## Unitary Products Technical Services Service Tips Letter

Letter: **ST-006-2017**

Subject: S1-3732797500\* Aluminum Service "A" Coil Horizontal Drain

Product: S1-3732797500\* Aluminum Service A coils for FC/PC/MC, AHV/AHE/AHR

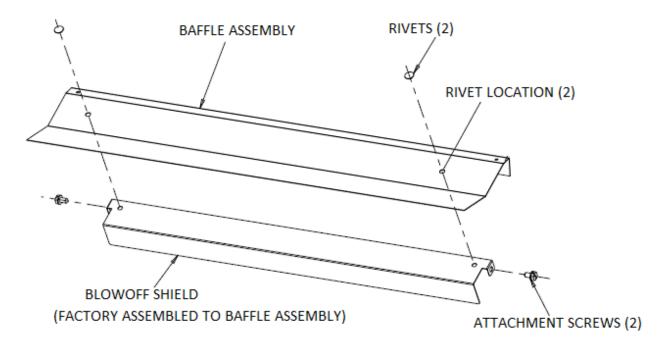
The current aluminum service "A" coil contains a top baffle assembly as shown below.

On October 10<sup>th</sup>, 2012 the MC model indoor coil top baffle was changed to a different style. This required different parts to connect the coil top baffle to the horizontal drain pan. An image of the new style top baffle is shown on the next page.

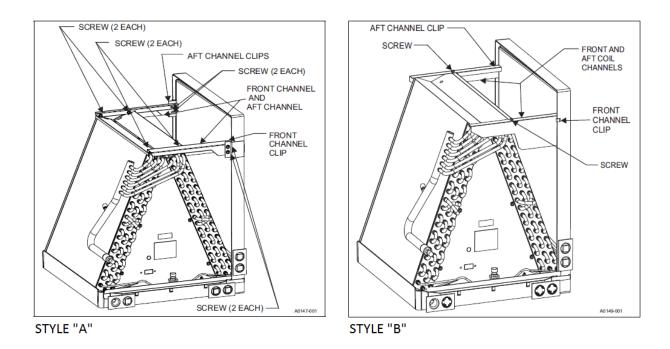
All MC model indoor coils and AHV/AHE/AHR model air handling units contain a factory installed horizontal drain pan. There are two styles of parts that fasten the coil top baffle assembly to the horizontal drain pan. Style A uses a clamp and screws to attach to the horizontal drain pan. Style B uses a clip to attach to the horizontal drain pan. These parts are referred to as a Condensate Channel Kit. The two different styles are shown below.

If the coil you are replacing has the style "A" condensate channel kit on it, the baffle assembly must be slightly modified. There is a set of tabs on the forward and aft portion of the coil top baffle assembly. These tabs must be bent up at a 90 degree angle to attach the front and rear condensate channel to the coil top baffle. See image below for screw tab location.

If the coil you are replacing has the style "B" condensate channel kit on it, the baffle assembly must be removed from the old coil and installed onto the new service "A" coil. Carefully remove the front and rear coil baffle attachment screws from the service "A" coil. Remove the style A coil baffle assembly and discard it. Remove the style B coil baffle assembly from the old coil. Style "A" has 4 screws and style "B" has two screws. Install the old style B coil baffle assembly onto the new service "A" coil. This will allow attachment of the style B front and rear condensate channels to the new service "A" coil so that the horizontal drain pan can be attached.

We are currently working to change the aluminum service "A" coil top baffle assembly to style B during coil production. We will also ship a new condensate channel kit with each service coil so that no top baffle assembly change will be necessary and the only part needed for re-use is the horizontal drain pan.
